ground floor plan

Option 3
Drawing No. 04

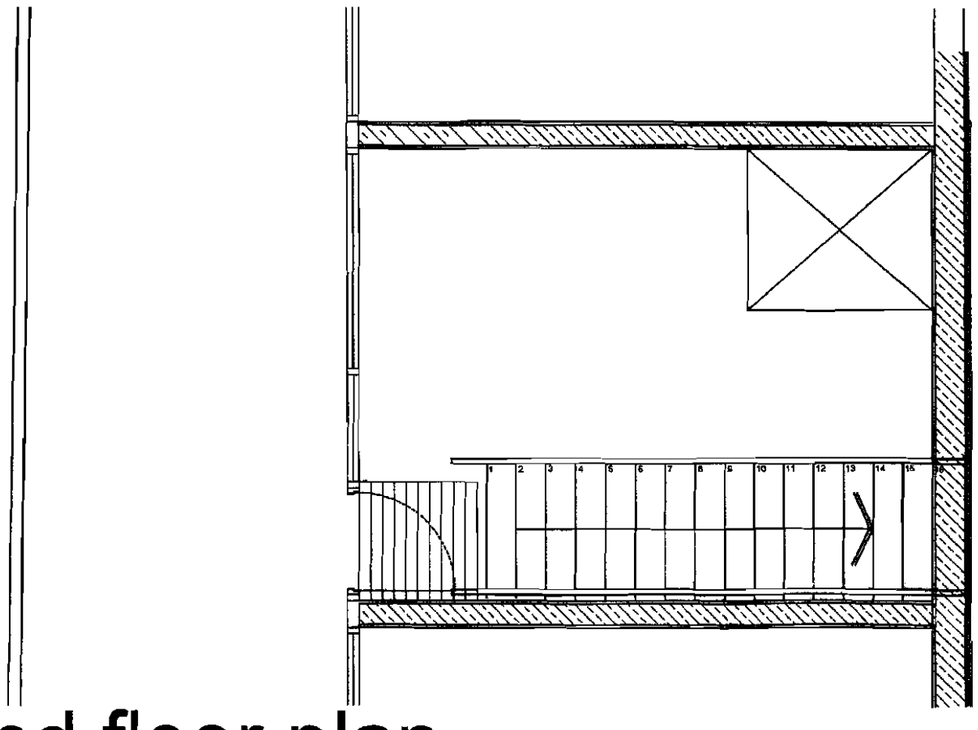
Limited reception space

Good access to lift

Stair does not conform to regulations

Entrance door clashes with stair
